Application for Variation of an Environmental Permit

C1. Name of the Current Environmental Permit Holder :
Drainage Services Department
C2. Application No. of the Current Environmental Permit : EP-516/2016
C3. The Current Environmental Permit was Issued in : month / year

ENVIRONMENTAL REVIEW REPORT (FINAL)

Port Shelter Sewerage, Stage 3 –
Sewerage Works at Po Toi O under
Environmental Permit No. 516/2016

Figure 2.1 Photo of Similar Silt Curtain Components

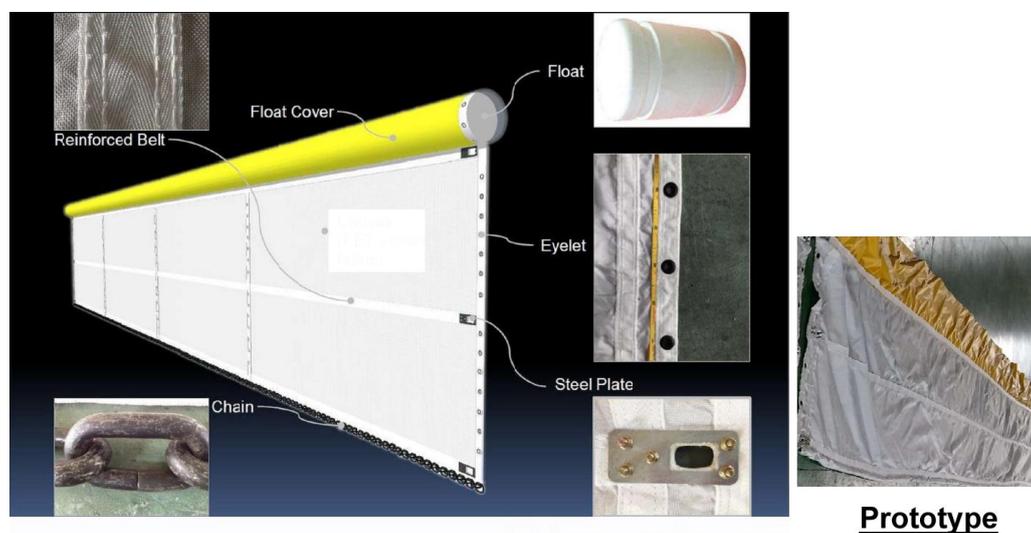
2.3.3 Typical silt curtain components are shown in **Figure 2.1**.

Figure 2.2 Indicative Arrangement of Enhanced Silt Curtain Barrier (Plan View)

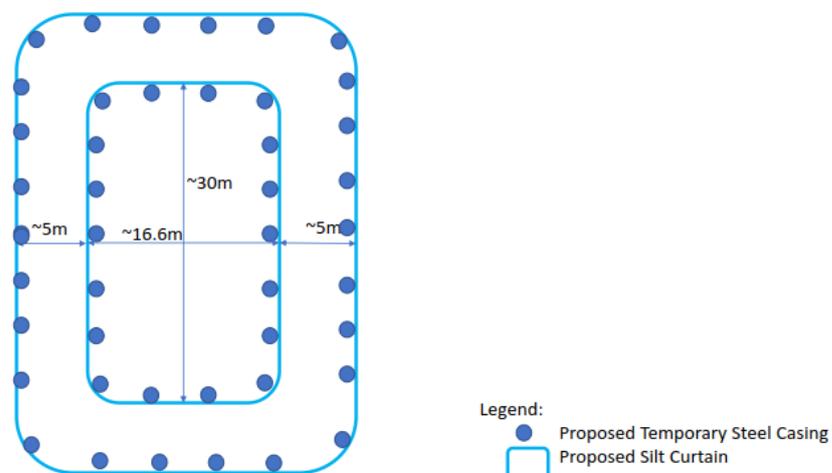
- 2.3.1 This section outlines the proposed replacement of the use of a fully enclosed watertight cofferdam by an enhanced double-layered silt curtain barrier for marine works (dredging, construction and installation works at diffuser location and backfilling).

- 2.3.6 The indicative arrangement of the enhanced double-layered silt curtain barrier is shown in **Figure 2.2**. The inner and outer layers of the barrier measure approximately 16.6 m × 30 m (498 m²) and 26.6 m × 40 m (1,064 m²), respectively.
